AGENCY:	City Council
MEETING DATE:	February 24, 2014
DEPARTMENT:	Community Dev'pmt
PREPARED BY:	T. Spade
PRESENTED BY:	T. Spade/ M. Jones

## AGENDA ITEM SUMMARY

**RECEIVE REPORT AND CONSIDER THE ADOPTION OF CITY COUNCIL RESOLUTION (1) UPHOLDING AN APPEAL BY WALNUT MAIN GROUP OF THE PLANNING COMMISSION'S DECEMBER 18, 2013 DECISION TO DENY PERMITS FOR CONVERSION OF EXISTING OFFICE BUILDING TO RETAIL USE/DOLLAR TREE (CDP 5-2013, DR 5-2013, UP 4-2013, AND LLA 1-2013); (2) ADOPTING MITIGATED NEGATIVE DECLARATION; AND (3) APPROVING CDP 5-2013, DR 5-2013, UP 4-2013, AND LLA 1-2013 (825 AND 845 SOUTH FRANKLIN STREET)**

Figure 1. Site plan depicting how loading zone can be located in rear 2/3 of lot.

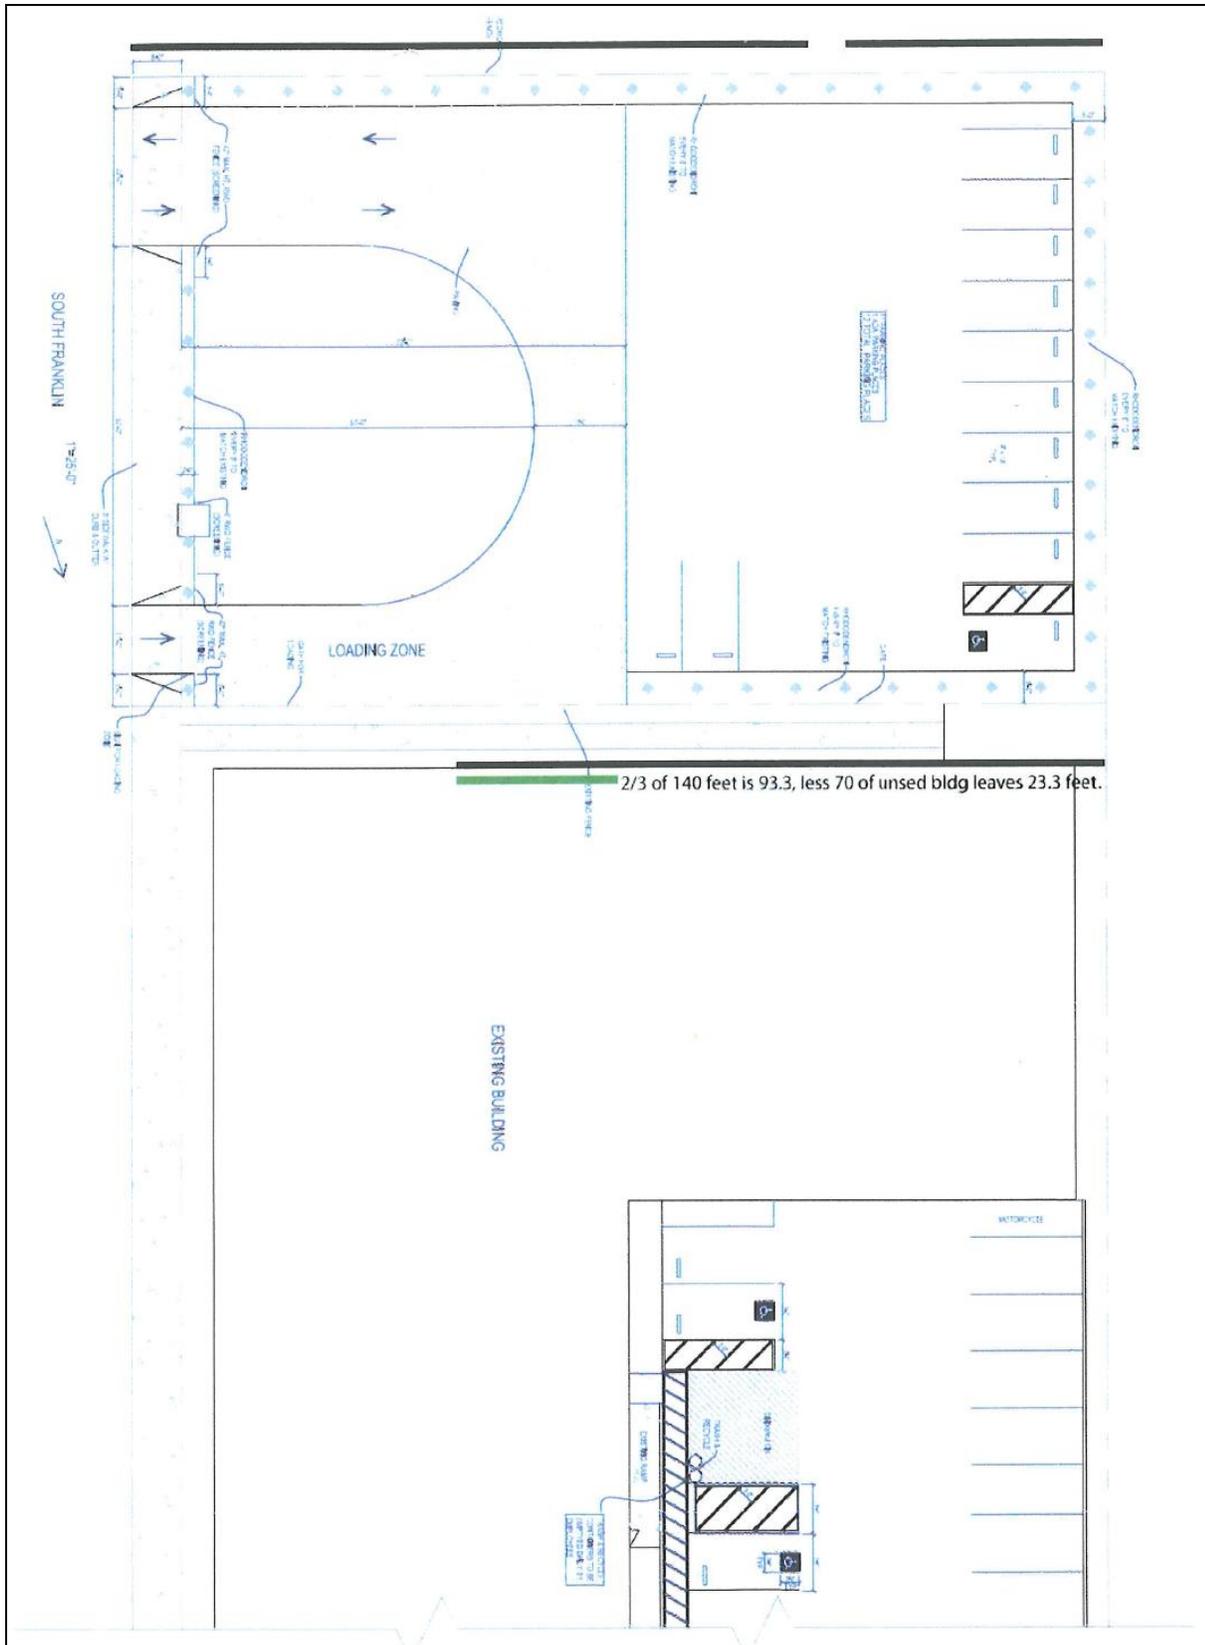
- 1. The loading zone shall face the building as illustrated by the site plan distributed by the Mayor and agreed to by the applicant at the meeting.***

It was determined that the loading zone could be located such that it would not face the street, and would in fact be located in the rear two-thirds of the property. Locating the loading zone this way would eliminate the need for an exception to CLUDC requirements and would assure consistency with CLUDC Sections 17.36.110.B.3.a and 17.36.110.B.3.c which require:

Figure 1, the site plan distributed by Mayor Turner at the January 27, 2014 City Council meeting, illustrates in green the depth of the lot that is located within the rear two-thirds of the property and also corresponds with the proposed loading zone turn-around area and portion of building to be leased by Dollar Tree.

Special Condition 3 has been revised to ensure that the loading zone location will be located such that it does not face the street and will be within the rear two-thirds of the parcel (new language in underlined text):

Special Condition 3: Prior to issuance of the Coastal Development Permit, a revised parking and circulation plan shall be submitted for approval by the Community Development Director. The new plan shall include striping in the vicinity of the loading zone area and shall include a loading zone lighting plan. The loading zone shall face the building as illustrated by the site plan distributed by the Mayor and agreed to by the applicant at the January 27, 2014 City Council meeting - the intent of this requirement is to assure the loading zone will not face the street and will be located within the rear two-thirds of the lot. The loading zone and associated driveways shall be paved prior to issuance of the building permit for the building improvements, and prior to occupancy.
